UNITED STATES PATENT AND TRADEMARK OFFICE

| APPLICATION NO. | FILING DATE | FIRST NAMED INVENTOR | ATTORNEY DOCKET NO. | CONFIRMATION NO. |
|-----------------|-------------|----------------------|---------------------|------------------|
| 10/811,374 | 03/26/2004 | Robert H. Bush | EH-11234 (04-224) | 2083 |

Office Action Summary

DETAILED ACTION***Claim Rejections - 35 USC § 102***

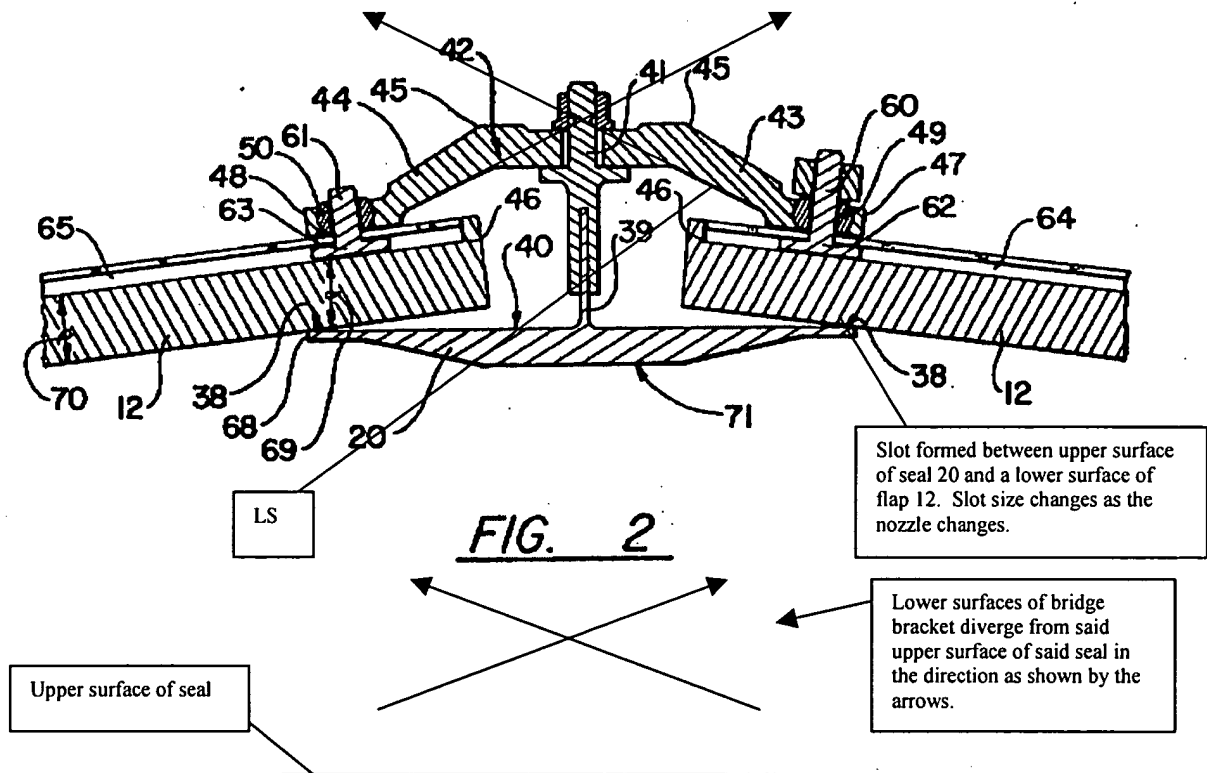
2. Claims 1-22 are rejected under 35 U.S.C. 102(b) as being anticipated by **Barcza** (U.S. 5,285,637).

With respect to claim 1, **Barcza** teaches a nozzle for an engine comprising: a plurality of spaced apart divergent flaps 12; means 34 for moving said divergent flaps 12; a bridge member

42 positioned intermediate adjacent ones of said divergent flaps 12; each said bridge member 42 including a bridge bracket (43, 44) and a sealing element 20 joined to said bridge bracket (43, 44); said sealing element 20 having an upper surface 40; and said bridge bracket having a lower surface LS which diverges from said upper surface of said sealing element 20. See particularly **Figure 2** of Barcza above.

With respect to claim 2, **Barcza** teaches that the divergent flaps 12 move relative to said lower surface LS so that in an overexpanded condition of said nozzle having a first nozzle throat area, a first slot is created between said upper surface of said seal member and lower surfaces of said flaps. See particularly **Figure 2**, column 4 lines 44-55 of Barcza.

With respect to claim 3, **Barcza** teaches that the divergent flaps 12 move relative to said lower surfaces so that in an overexpanded condition of said nozzle having a second nozzle throat area smaller than said first nozzle throat area, a second slot smaller than said first slot is created between said upper surface of said seal member and said lower surfaces of said flaps. See particularly **Figure 2**, column 4 lines 44-55 of Barcza.

With respect to claim 4, **Barcza** teaches that the nozzle further comprises means (39, 41) for joining said sealing element 20 to said bridge bracket (43, 44). See particularly **Figure 2** of Barcza above.

With respect to claim 5, **Barcza** teaches that the bridge bracket (43, 44) is shaped to allow variable slot size depending on nozzle throat jet area. See particularly **Figure 2**, column 4 lines 21-24 of Barcza.

With respect to claim 6, **Barcza** teaches that said divergent flaps 12 define a nozzle surface area and said flaps 12 being spaced apart by gaps* which comprise from 3.0% to 30% of said nozzle throat surface area. See particularly **Figure 2** of Barcza above.

*The gap between adjacent flaps appears to be within the claimed range of 3.0% to 30%.

With respect to claim 7, **Barcza** teaches that said divergent flaps 12 are spaced apart by gaps* which comprise from 8.0% to 12.0% of said nozzle throat surface area. See particularly **Figure 2** of Barcza above.

*The gap between adjacent flaps appears to be within the claimed range of 8.0% to 12.0%.

With respect to claim 8, **Barcza** teaches an ejector nozzle bridge member 42 comprising: a bridge bracket (43, 44); a sealing element 20 joined to said bridge bracket; said sealing element having an upper surface 40; and said bridge bracket having a lower surface LS which diverges from said upper surface of said sealing element. See particularly **Figure 2** of Barcza above.

With respect to claim 9, **Barcza** teaches that the sealing element 20 has a central portion and end portions an angle to said central portion. See particularly **Figure 2** of Barcza above.

With respect to claim 10, **Barcza** teaches that the ejector nozzle bridge member further comprises: a backbone support (39, 41) attached to said sealing element 20; said bridge bracket 42 fitting over said backbone support; and means for securing said bridge bracket on said backbone support. See particularly **Figure 2** of Barcza above.

With respect to claim 11, **Barcza** teaches that the bridge bracket (43, 44) is shaped to allow variable slot size depending on nozzle throat jet area. See particularly **Figure 2**, column 4 lines 21-24 of Barcza.

With respect to claim 12-22, **Barcza** teaches a nozzle for an engine comprising: a plurality of spaced apart divergent flaps 12; means 34 for moving said divergent flaps 12; a bridge member 42 positioned intermediate adjacent ones of said divergent flaps 12; each said bridge member 42 including a bridge bracket (43, 44) and a sealing element 20 joined to said bridge bracket (43, 44); said sealing element 20 having an upper surface 40; and said bridge bracket having a lower surface LS which diverges from said upper surface of said sealing element 20. Since **Barcza** has the same structure as claimed, it is inherent that **Barcza's** ejector nozzle would be able to perform the recited method steps of claims 12-22. See particularly **Figure 2**, column 4 lines 21-24; and column 4 lines 44-55 of **Barcza**.

FIG. 3

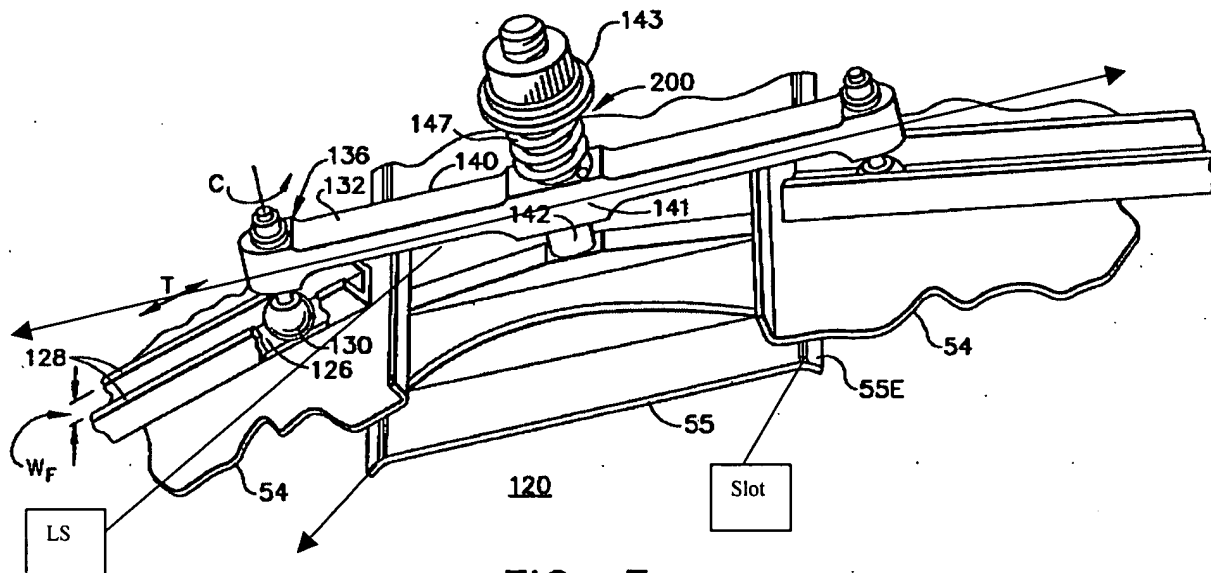
3. Claims 1-22 are rejected under 35 U.S.C. 102(b) as being anticipated by **Ausdenmoore et al.** (U.S. 5,484,105).

With respect to claim 1, **Ausdenmoore** teaches a nozzle for an engine comprising: a plurality of spaced apart divergent flaps 54; means 90 for moving said divergent flaps 54; a bridge member 141 positioned intermediate adjacent ones of said divergent flaps 54; each said bridge member 141 including a bridge bracket 132 and a sealing element 55 joined to said bridge bracket 132; said sealing element 55 having an upper surface 55E which diverges from a lower surface LS of said bridge bracket. See particularly **Figure 3** of Ausdenmoore above.

*a sealing element having an upper surface which diverges from a lower surface of a bridge bracket is interpreted to mean the same or be equivalent to a bridge bracket having a lower surface which diverges from an upper surface of a sealing element.

With respect to claim 2, **Ausdenmoore** teaches that the divergent flaps 54 move relative to said lower surface LS so that in an overexpanded condition of said nozzle having a first nozzle

throat area, a first slot is created between said upper surface of said seal member and lower surfaces of said flaps. See particularly **Figure 3** of Ausdenmoore above..

With respect to claim 3, **Ausdenmoore** teaches that the divergent flaps 54 move relative to said lower surfaces so that in an overexpanded condition of said nozzle having a second nozzle throat area smaller than said first nozzle throat area, a second slot smaller than said first slot is created between said upper surface of said seal member and said lower surfaces of said flaps. See particularly **Figure 3** of Ausdenmoore above..

With respect to claim 4, **Ausdenmoore** teaches that the nozzle further comprises means 142 for joining said sealing element 55 to said bridge bracket 132. See particularly **Figure 3** of Ausdenmoore above.

With respect to claim 5, **Ausdenmoore** teaches that the bridge bracket 132 is shaped to allow variable slot size depending on nozzle throat jet area. See particularly **Figure 3** of Ausdenmoore above.

With respect to claim 6, **Ausdenmoore** teaches that said divergent flaps 54 define a nozzle surface area and said flaps being spaced apart by gaps* which comprise from 3.0% to 30% of said nozzle throat surface area. See particularly **Figure 3** of Ausdenmoore above.

*The gap between adjacent flaps appears to be within the claimed range of 3.0% to 30%.

With respect to claim 7, **Ausdenmoore** teaches that said divergent flaps 54 are spaced apart by gaps* which comprise from 8.0% to 12.0% of said nozzle throat surface area. See particularly **Figure 3** of Ausdenmoore above.

*The gap between adjacent flaps appears to be within the claimed range of 8.0% to 12.0%.

With respect to claim 8, **Ausdenmoore** teaches an ejector nozzle bridge member 141 comprising: a bridge bracket 132 and a sealing element 55 joined to said bridge bracket 132; said sealing element 55 having an upper surface 55E which diverges from a lower surface LS of said bridge bracket. See particularly **Figure 3** of Ausdenmoore above.

*a sealing element having an upper surface which diverges from a lower surface of a bridge bracket is interpreted to mean the same or be equivalent to a bridge bracket having a lower surface which diverges from an upper surface of a sealing element.

With respect to claim 9, **Ausdenmoore** teaches that the sealing element 55 has a central portion and end portions an angle to said central portion. See particularly **Figure 3** of Ausdenmoore above.

With respect to claim 10, **Ausdenmoore** teaches that the ejector nozzle bridge member further comprises: a backbone support 142 attached to said sealing element 55; said bridge bracket 132 fitting over said backbone support; and means for securing said bridge bracket on said backbone support. See particularly **Figure 3** of Ausdenmoore above.

With respect to claim 11, **Ausdenmoore** teaches that the bridge bracket 132 is shaped to allow variable slot size depending on nozzle throat jet area. See particularly **Figure 3** of Ausdenmoore above.

With respect to claim 12-22, **Ausdenmoore** teaches a nozzle for an engine comprising: a plurality of spaced apart divergent flaps 54; means 90 for moving said divergent flaps 54; a bridge member 141 positioned intermediate adjacent ones of said divergent flaps 54; each said bridge member 141 including a bridge bracket 132 and a sealing element 55 joined to said bridge bracket 132; said sealing element 55 having an upper surface 55E which diverges from a lower

surface LS of said bridge bracket. Since **Ausdenmoore** has the same structure as claimed, it is inherent that **Ausdenmoore**'s ejector nozzle would be able to perform the recited method steps of claims 12-22. See particularly **Figure 3** of Ausdenmoore above.
